Planning and Zoning Commission

September 1, 2020

TO: Planning and Zoning Commission
FROM: Evann Martin, Assistant Planner
DATE: September 1, 2020
RE: Prairie Business Park Parking Expansion – Site Plan Amendment

RE: Prairie Business Park Parking Expansion Site Plan

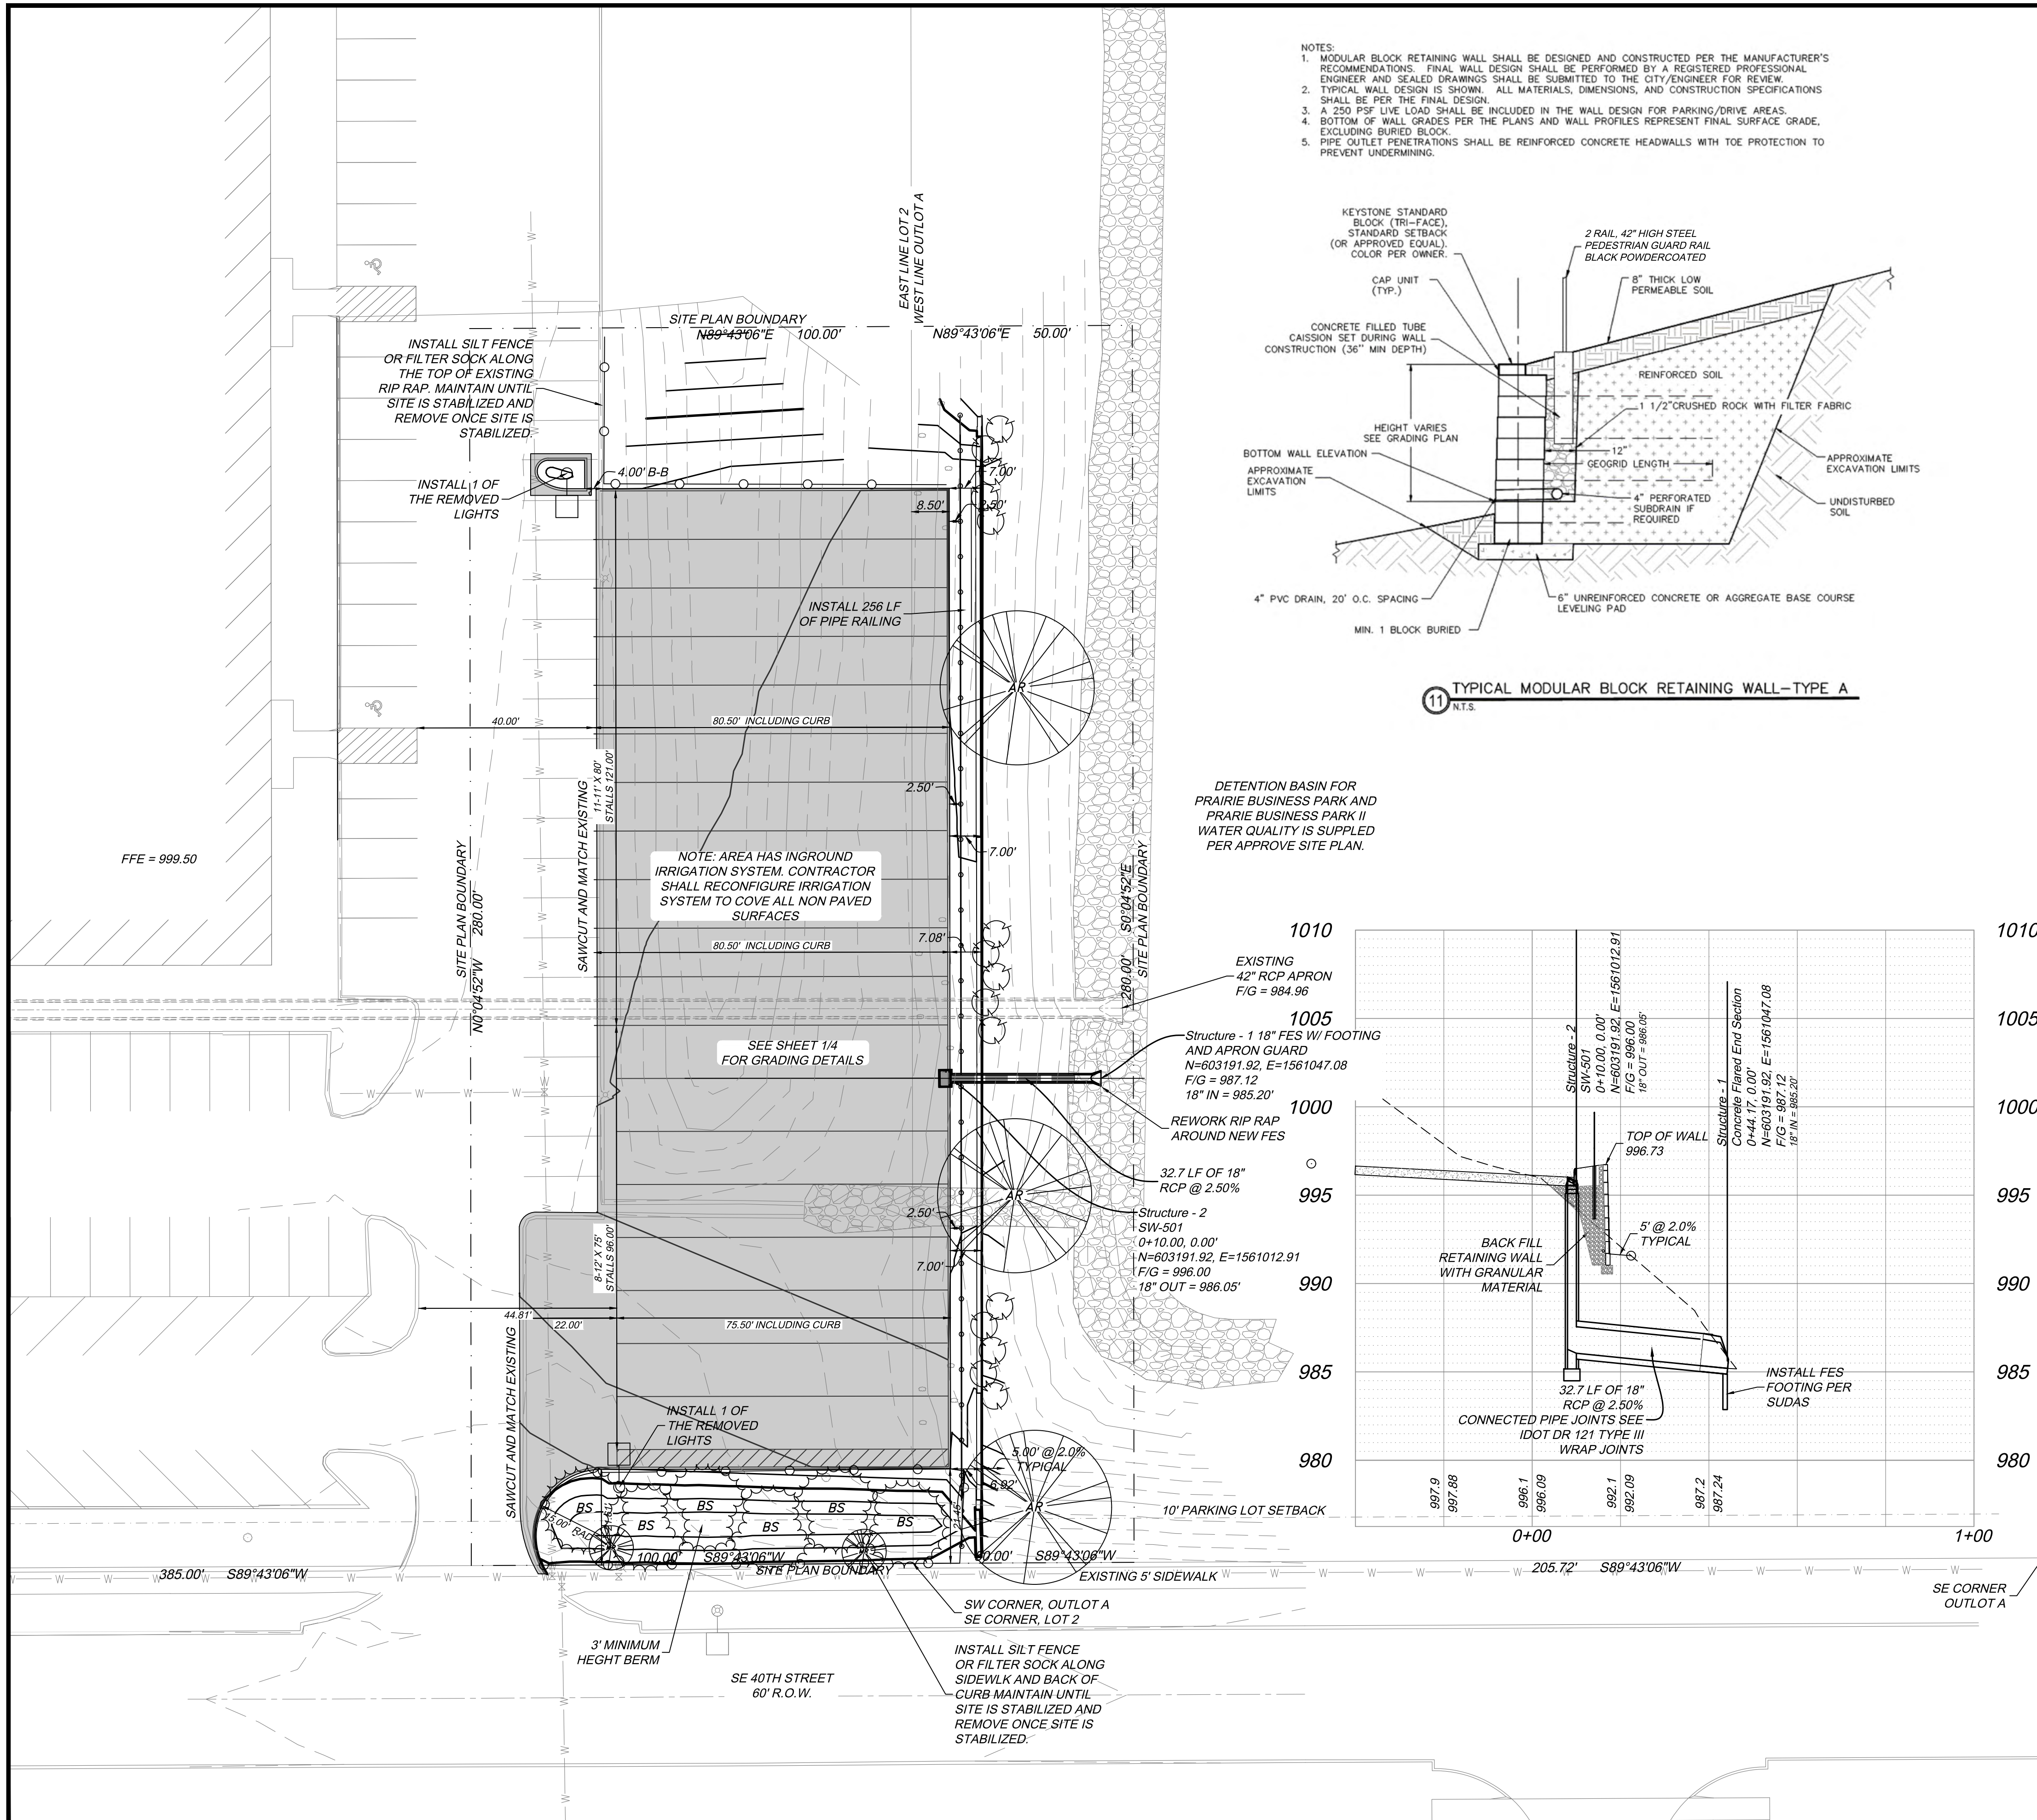
1. ~~Update zoning to address recent zoning amendment permitting logged vehicles onsite.~~ **Ordinance number is 737.**
2. ~~Add proposed/ current use of site.~~
3. ~~Provide a copy of the lot tie agreement.~~
4. ~~Verify spelling on notes on page 3 & 4 about irrigation.~~
5. ~~Provide engineering report for the retaining wall.~~ **We will need to have the complete wall design for review prior to construction. Grading can begin with a grading and utility permit.**
6. ~~Show railing on top of the retaining wall and provide detail.~~

1. ~~Please provide more detailed calculation to demonstrate that the green space requirement is still being met with the addition of the parking lot.~~
2. ~~Callout berm and height. 3' minimum.~~

- ~~3. Please provide more plantings along SE 40th Street. There should be 8-9 trees. Please update plant counts in the plant schedule.~~

- ~~1. Provide a sediment and erosion control plan.~~
2. Sheet 2/4: Note to include either silt fence or require a strip of existing vegetative buffer between the retaining wall and basin rip rap to reduce risk of sedimentation along east construction boundary.

1. Observations from SUDAS Design 2C-3 indicate the transition from weir to orifice for a Type R grate occurs at $d=0.5$ -ft. For the 5-year a weir depth = 0.42' and orifice depth = 0.21' was calculated (weir controlling). For the 100-year a weir depth = 0.64' and orifice depth = 0.75' was calculated (orifice controlling). According to the narrative the 100-year would overtop the retaining wall. Please verify the above calculations and adjust site plan as necessary to not overtop the wall during the 100-year storm. It may be worth it to use an SW-505.

REFERENCE NUMBER:
DRAWN BY: CLT
CHECKED BY: JEJ
REVISION DATE: 1ST CITY SET 6/22/20 2ND CITY SET 8/14/20 3RD CITY SET 8/25/20
PROJECT NUMBER: 190434
SHEET NUMBER: C4.1

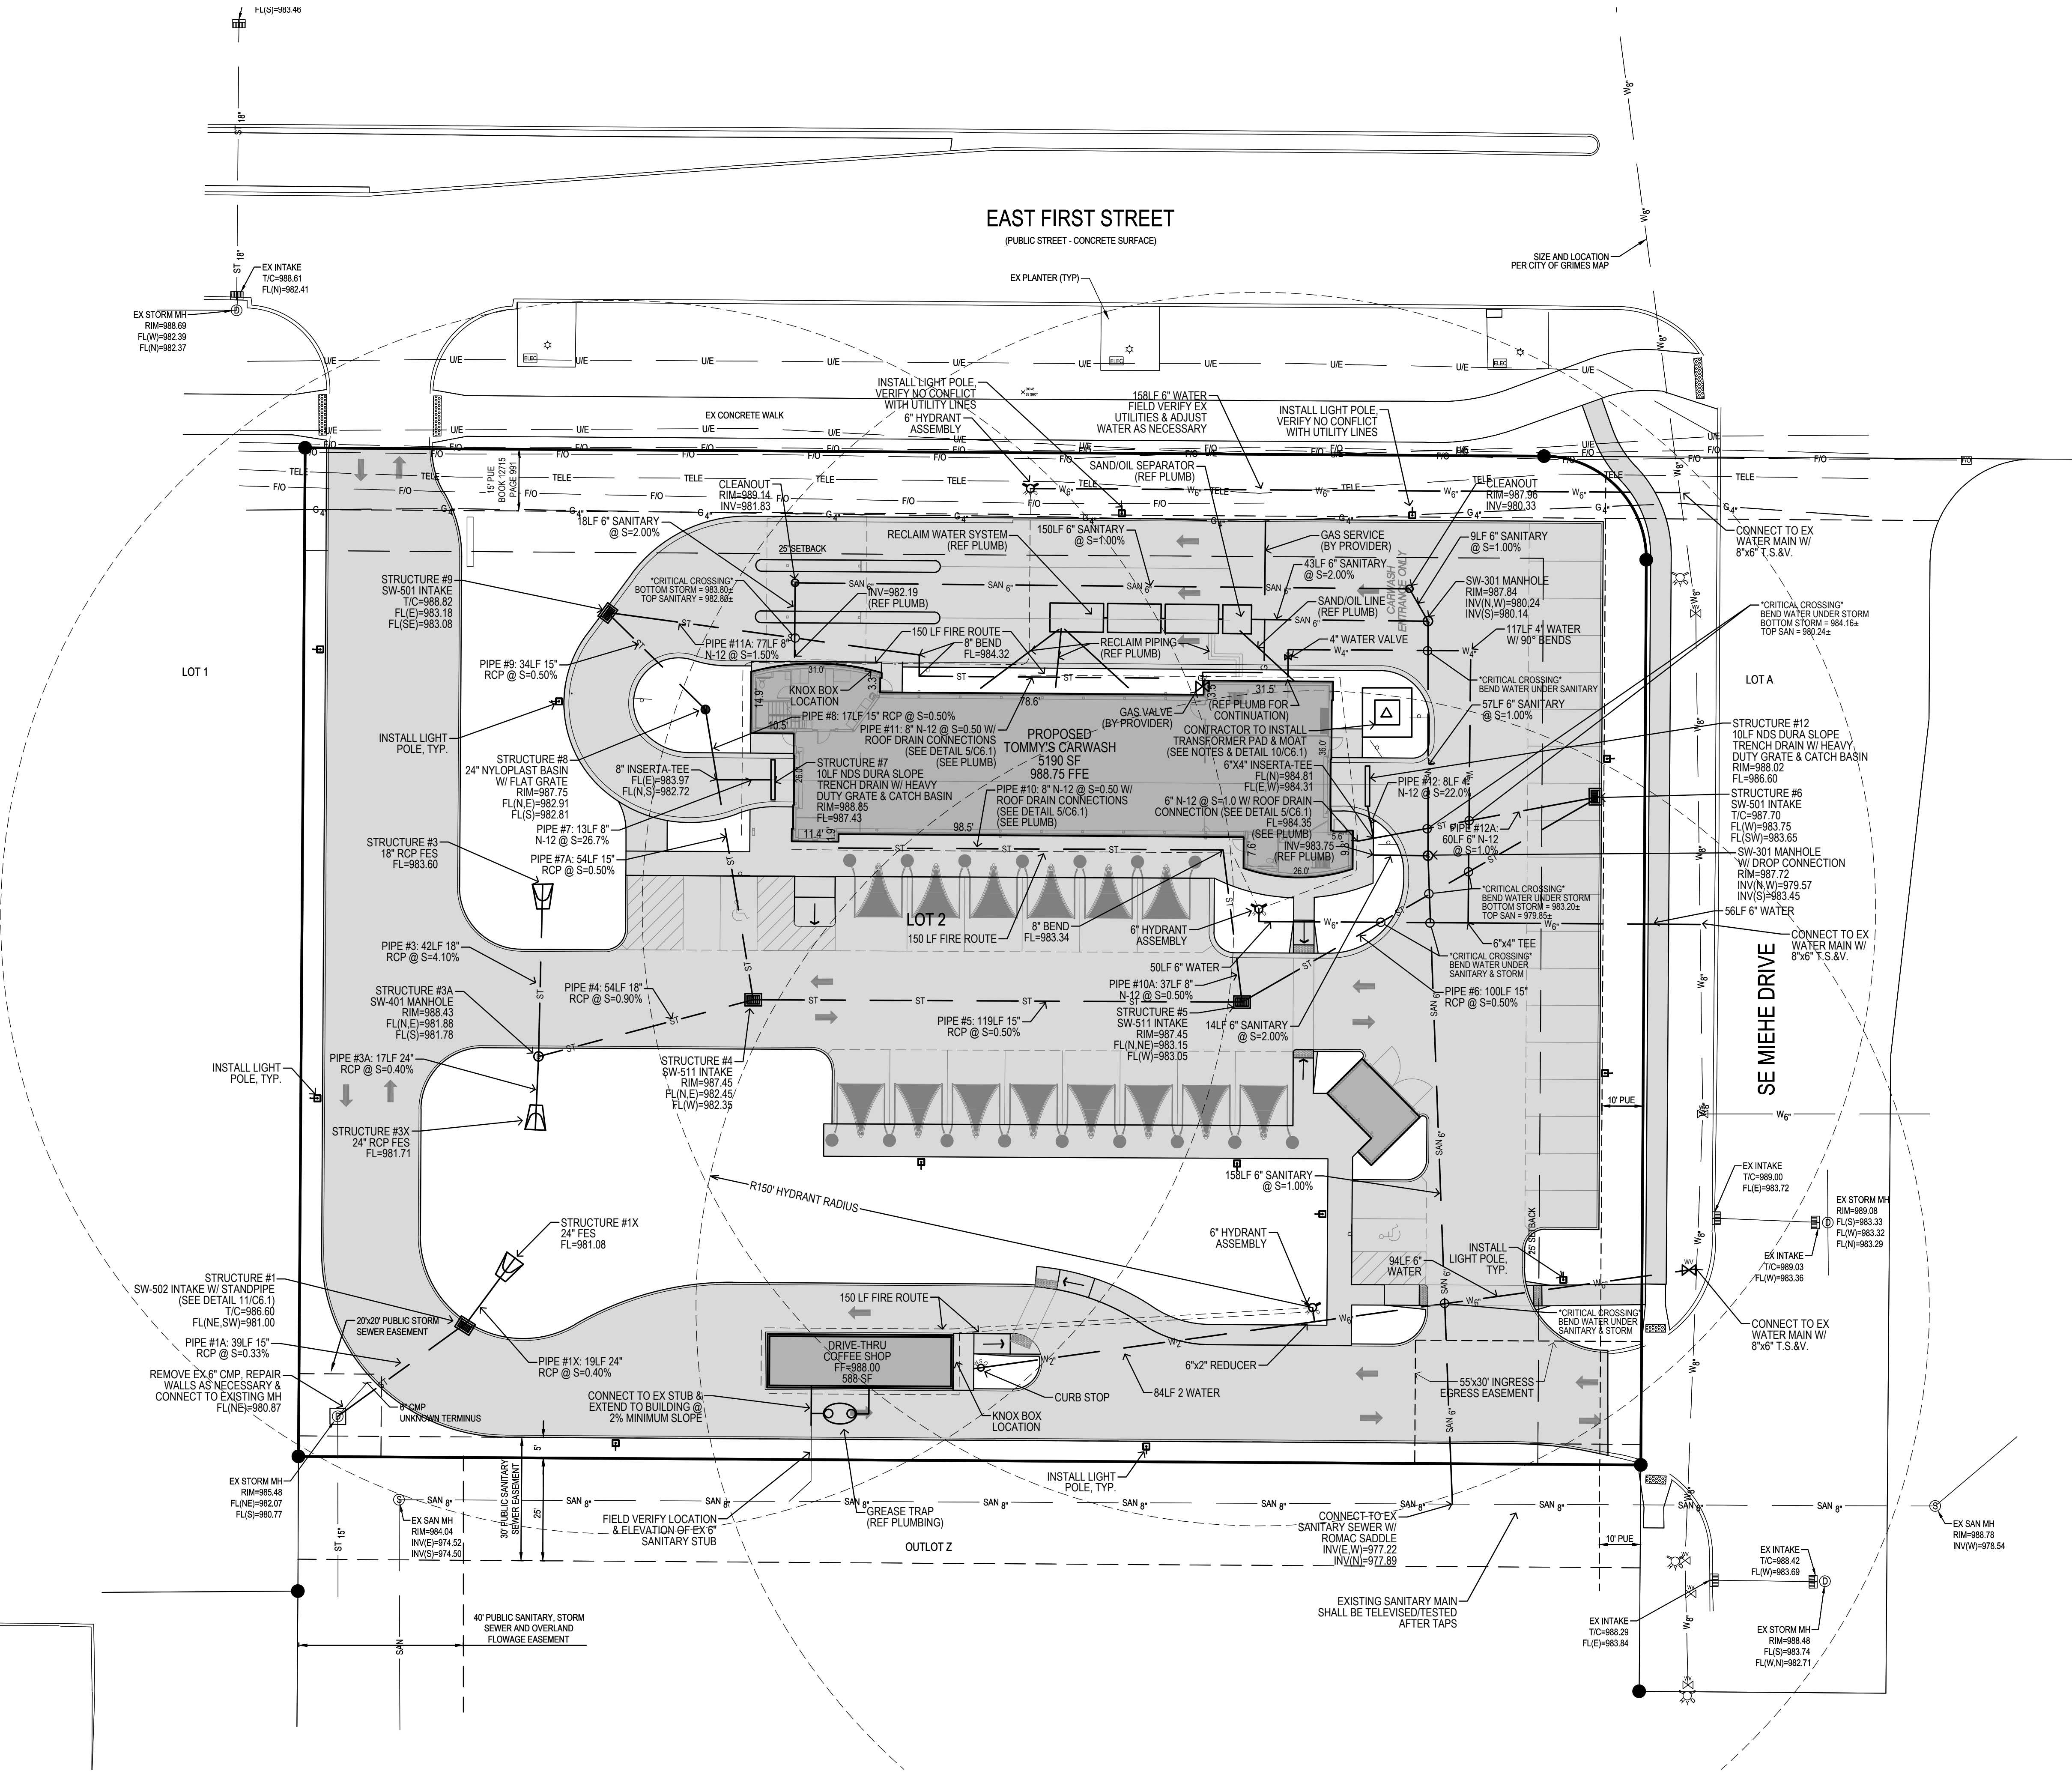
6. ~~Existing sanitary main will need to be televised/tested after taps (use Romac Saddle) are made.~~
7. ~~Can the existing sanitary sewer stub be utilized (see Sheet 3 of 11 of Destination Ridge Plat 5 Plans). If not used the service will need to be capped at the main.~~
